April 22, 2020

Re: Abbreviated Notice of Resource Area Delineation (ANRAD)
Pratt Corner Road West
Shutesbury, MA
(Parcel ID ZW-6)
DEP File # 286-0277
Wetland Consultant Peer Review Proposal

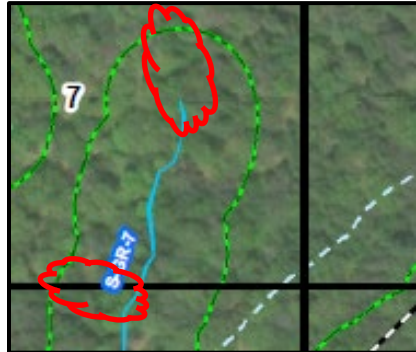
- b. W-GR-4 should be adjusted outward to incorporate dominant wetland vegetation and hydrology. The wetland system extends further to the north and drains westerly, ultimately converging with stream S-GR-7. Therefore, W-GR-4 is bordering not isolated. Wetland and Bank delineation should be expanded between W-GR-4 and S-GR-7 (Sheet 7 of 14).

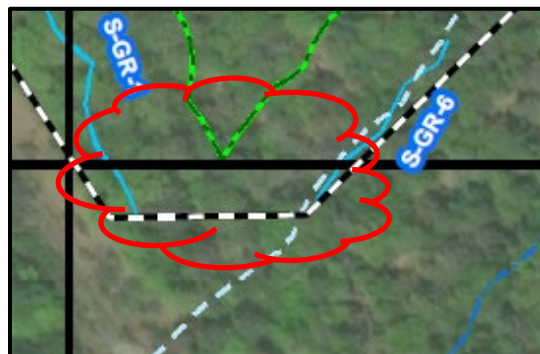
- d. Based on surface inundation, saturated soils, hydric soils and dominant wetland plant species, there is an unmapped wetland upgradient of stream S-GR-1 (Sheets 10 of 14)

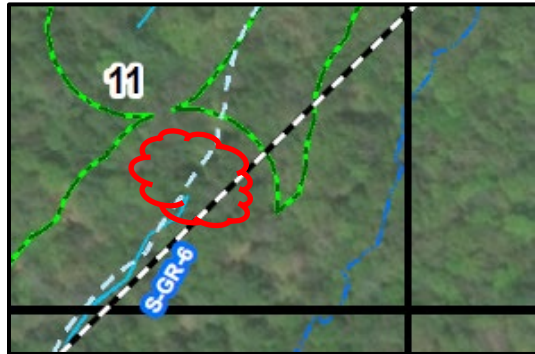
- e. Based on surface inundation, saturated soils, hydric soils and dominant wetland plant species, there is an unmapped wetland between streams S-GR-1 and S-GR-6 (Sheets 11 and 13 of 14).
